**Record of Decision**  
**Erdle Perforating Site**  
**State Superfund Project**  
**Town of Gates, Monroe County, New York**  
**Site Number 828072**

**December 2010**

# **DECLARATION STATEMENT - RECORD OF DECISION**

Proposed Electrical Resistance Heating (ERH) Remedy Layout  
Figure 7

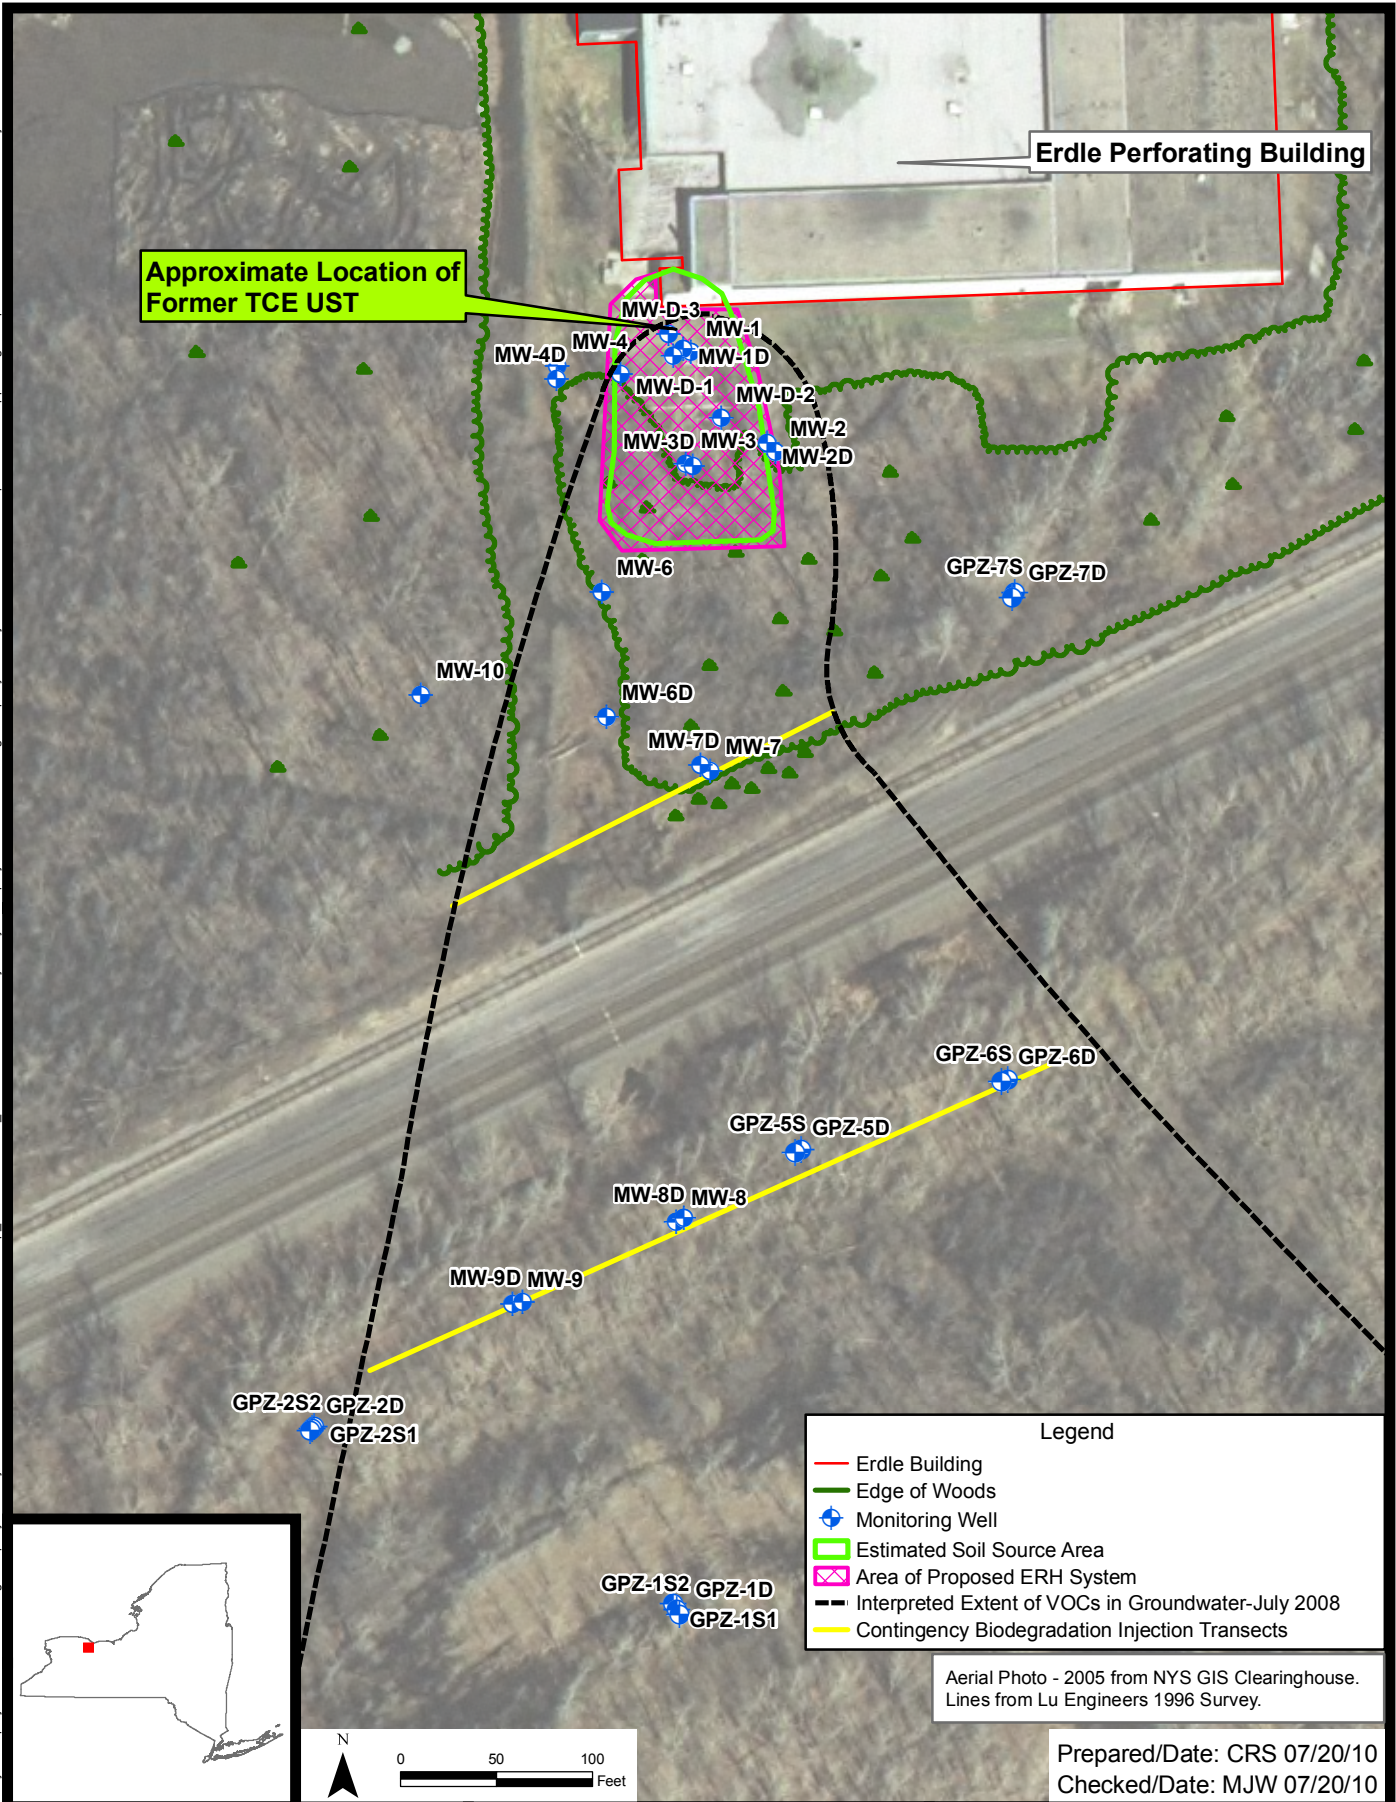
**COMMENT 15:** Will the heat turn the liquid into vapors? How well will you capture the contamination with the heat treatments?

**COMMENT 18:** How deep are the electrodes going?

**RESPONSE 15:** Once the soils are heated the volatile organic contamination will essentially boil off. The heat will be generated by passing electricity through the soil between the electrodes. The treatment area will be covered by plastic sheeting to contain the vapors and the vapors that are generated will be removed from the soils through soil vapor extraction points. These extraction points will be installed at each location where an electrode will be installed. The collected vapor will be treated.

**RESPONSE 18:** The electrodes will be installed down to bedrock, generally between 10 and 15 feet below the ground surface.
